Docket No. 50-344

SUBJECT: SPIRIT LAKE/TROJAN PLANT FLOODING SER

HYDROLOGIC ENGINEERING SAFETY EVALUATION REPORT
CONCERNING A POSTULATED BREAKOUT OF SPIRIT LAKE
AND ITS IMPACTS ON THE TROJAN PLANT

FIGURE 2
LOCATION OF SPIRIT LAKE OUTLET

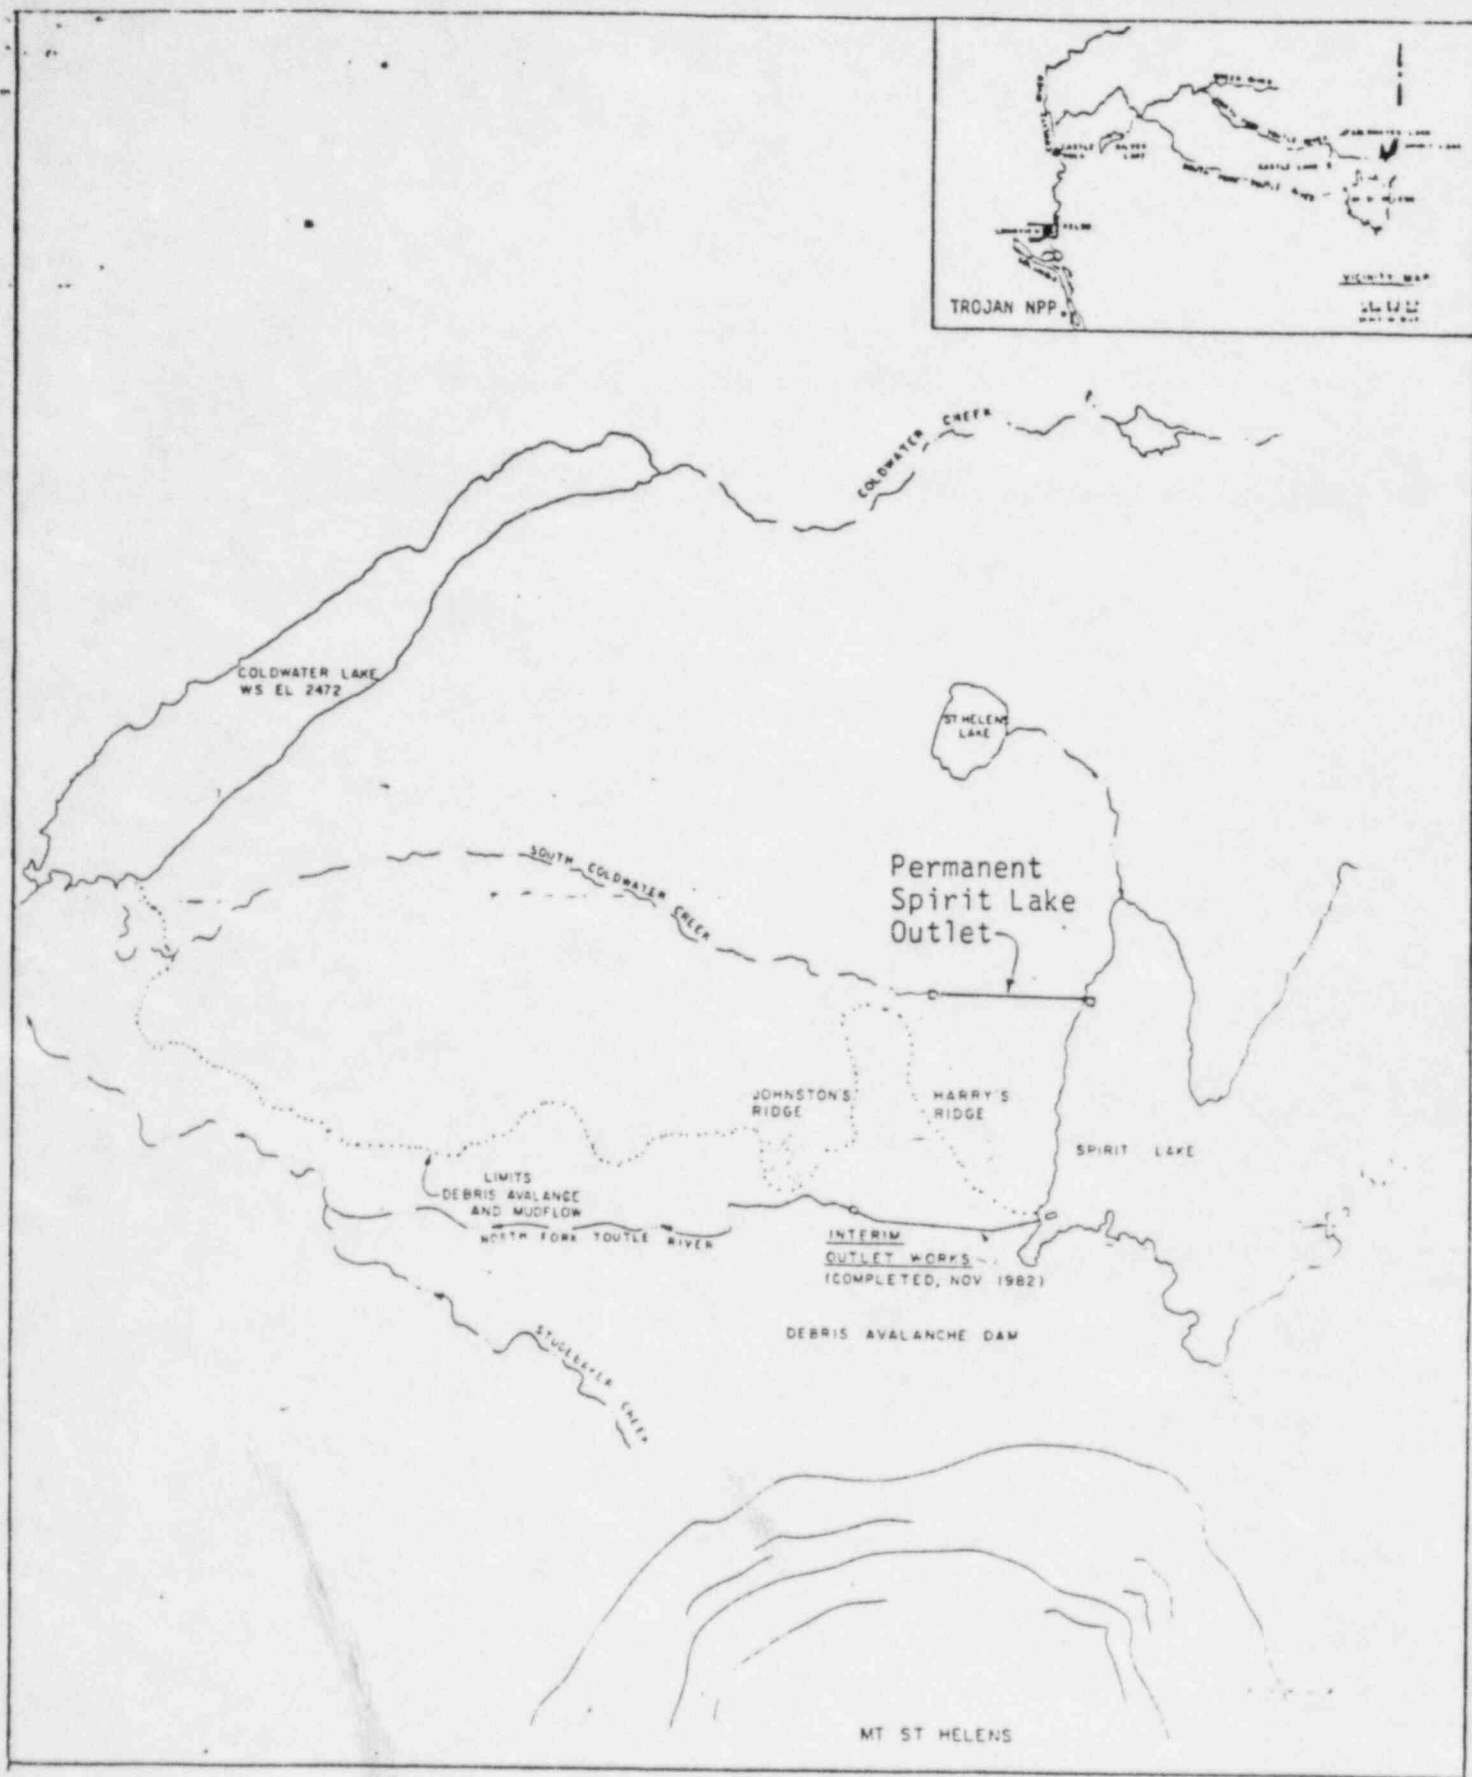
The tunnel being constructed between Spirit Lake and South Coldwater Creek (See Figure 2) will provide a permanent outlet for Spirit Lake. This tunnel will permanently lower the level of Spirit Lake and remove the threat of a breakout and the potential for high water in the Columbia River at the Trojan Plant.
